ASR Feasibility in Bandera County

Plateau Region Water Planning Group
and
Texas Water Development Board

Response to TWDB Comments on Draft Final Region-Specific Study Reports

Region J, Region-Specific Contract Study #2 *Water Rights Analysis and ASR Feasibility in Kerr County;* *ASR Feasibility in Bandera County*

Figure 3.1 Annual diversions from the Medina River in the vicinity of the City of Bandera

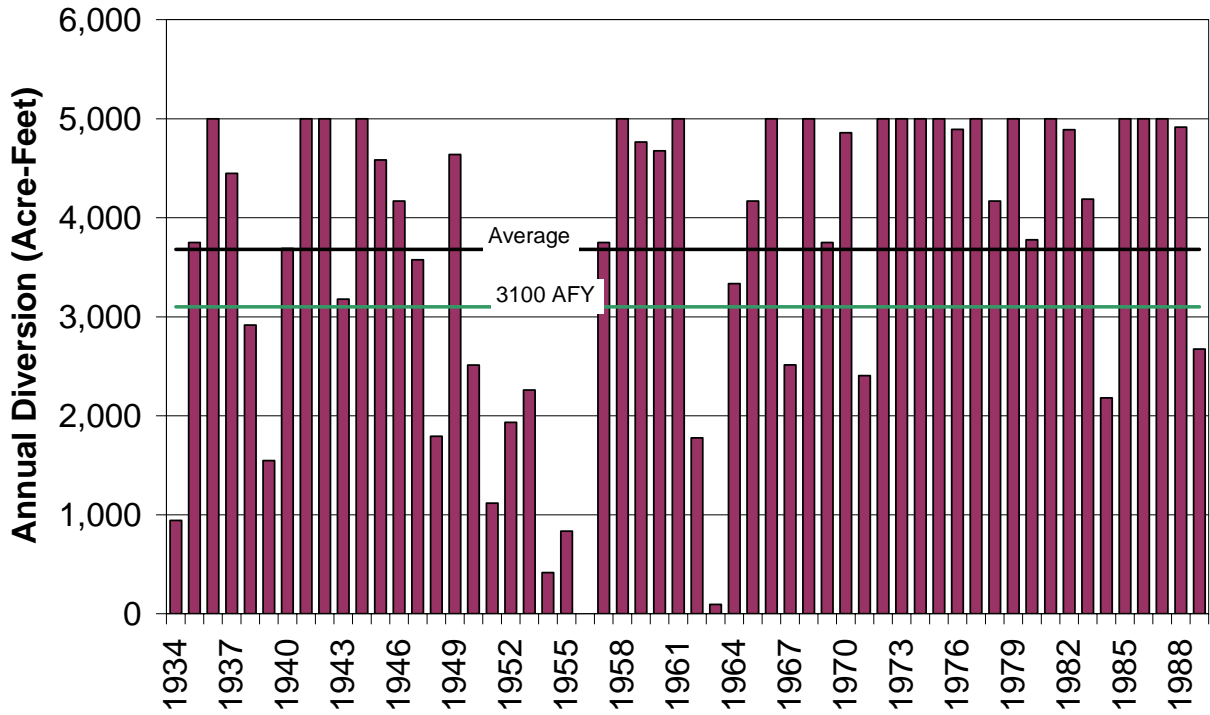
4. Report 2, Page 3-3, Figure 3.1: Please add units to the axes of the graph in the final report.

*Response: Units are added to the graph.*

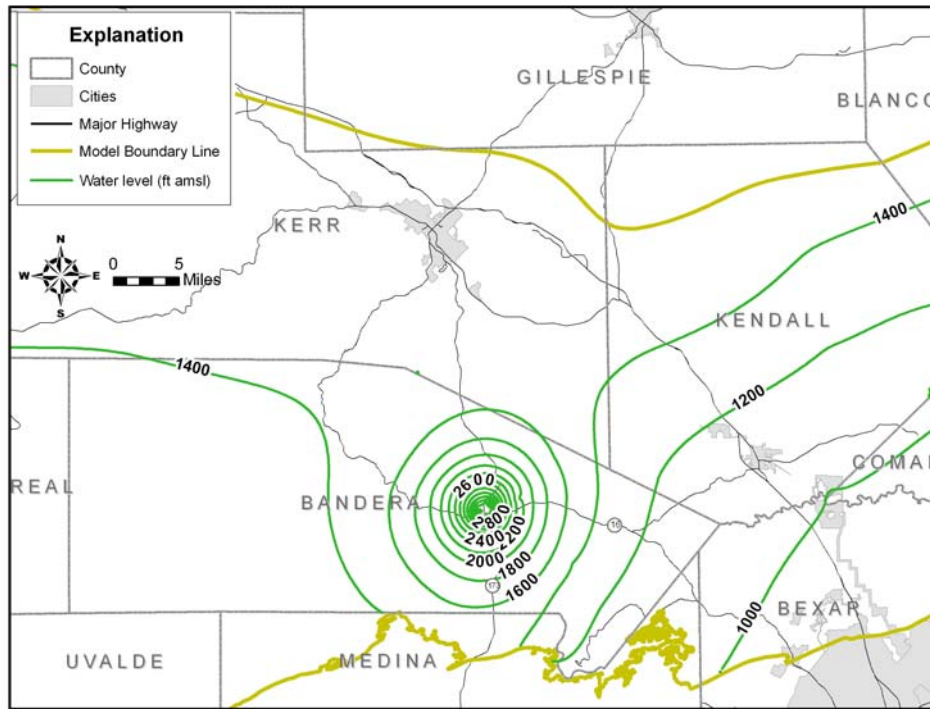
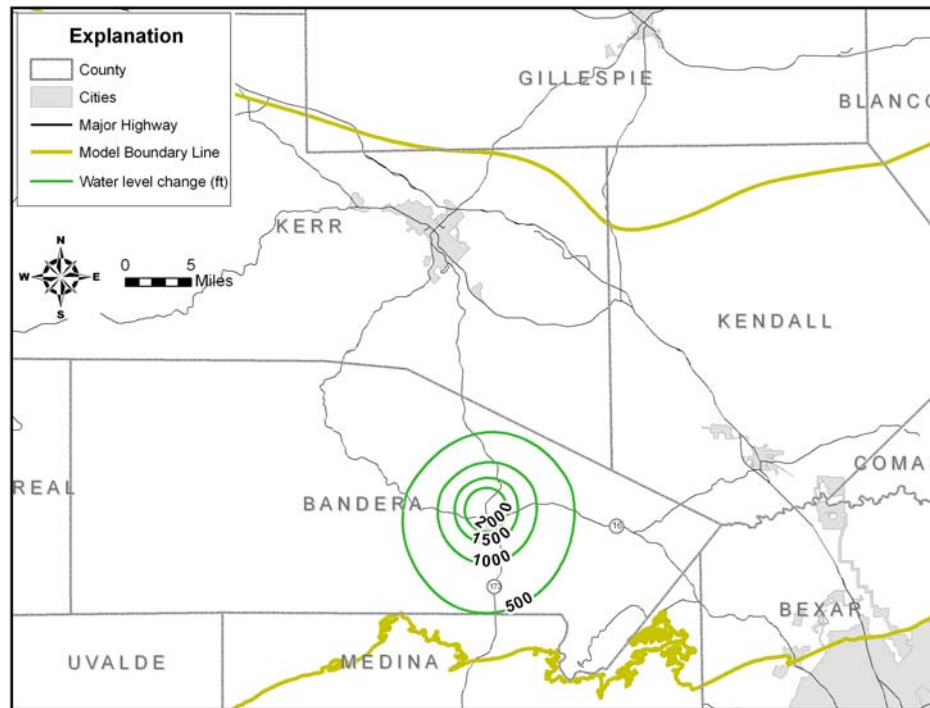
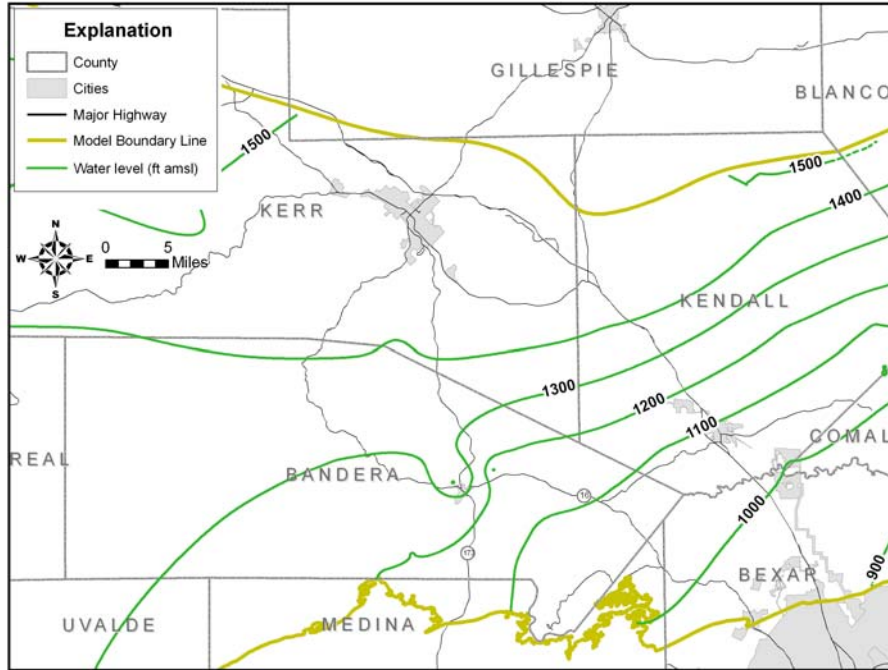
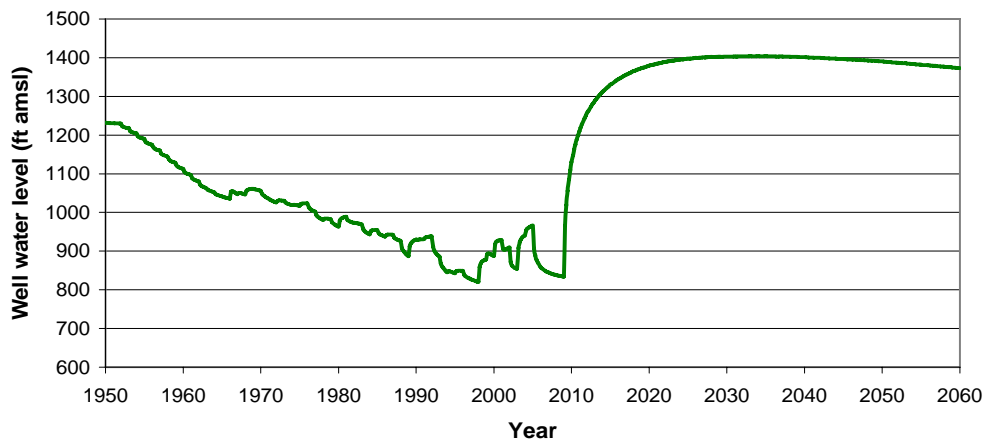
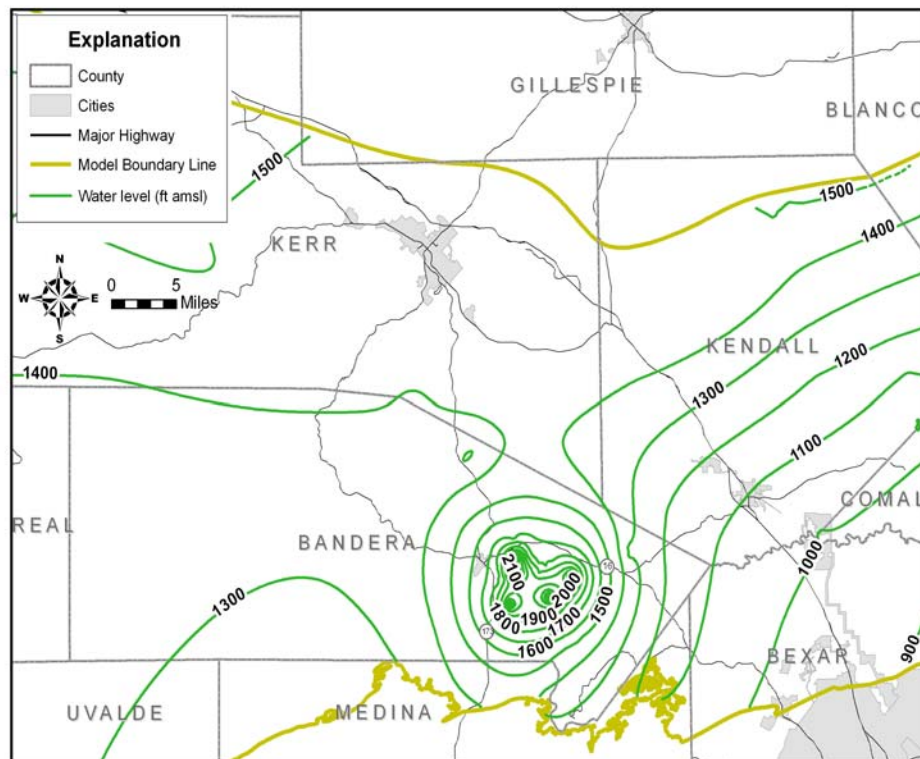
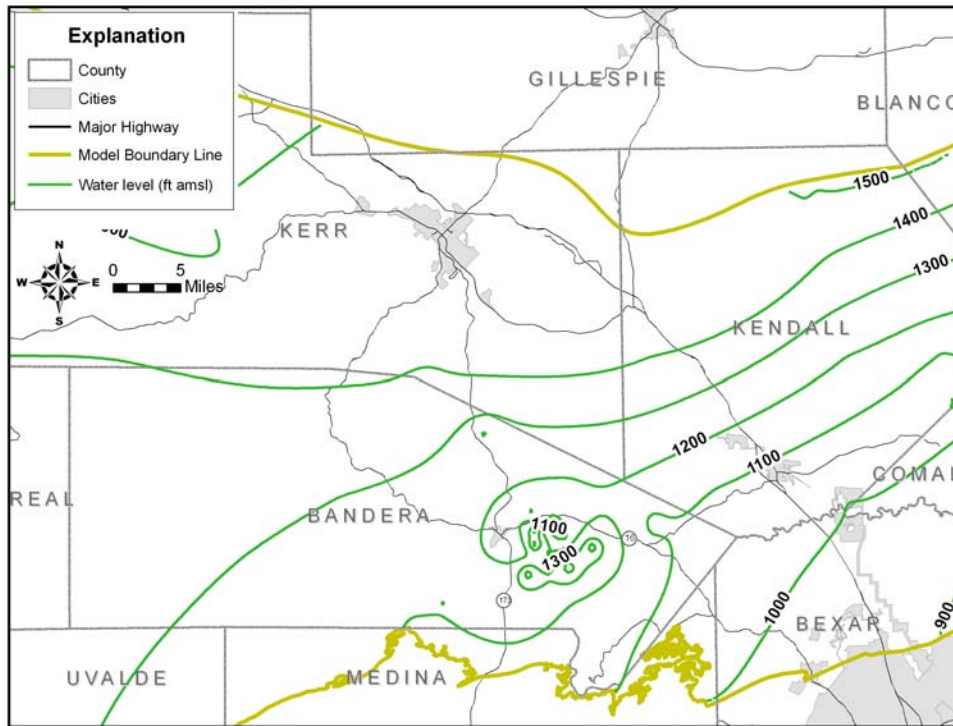
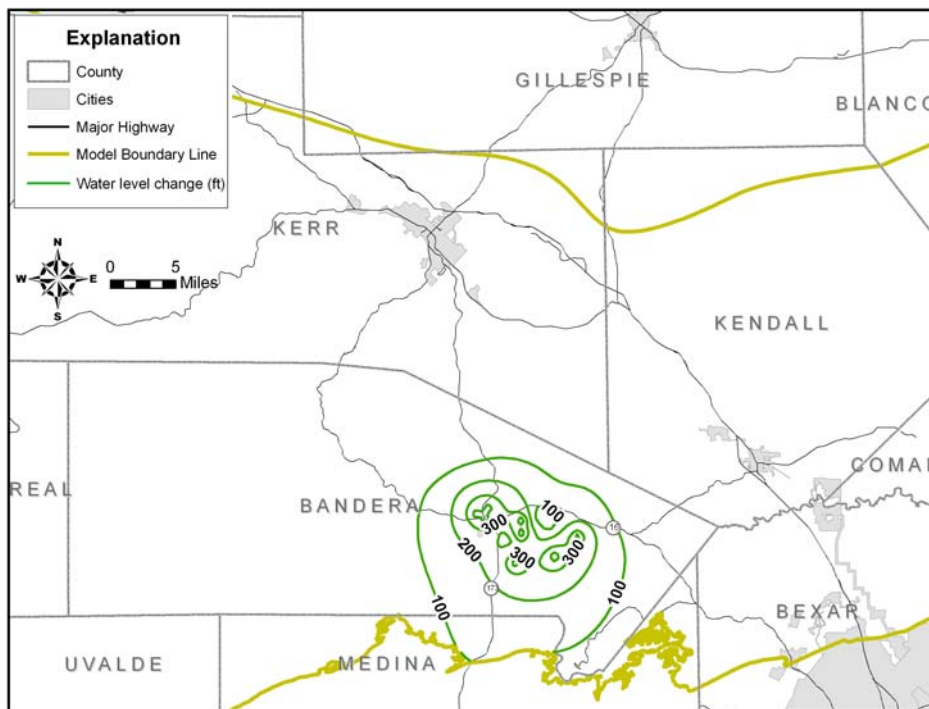
8. Report 2, Section 5 Figures: (a) pages 5-4 to 5-7, Figures 5.1 to 5.7: Please identify the year for which water levels and water level changes are shown in these figures; (b) page 5-6: Please consider including water levels and water level changes for Scenario 2a in the final report.

*Response: Figure titles have been revised to show conditions in 2060. Figure 5.5 now shows the Scenario 2a conditions.*
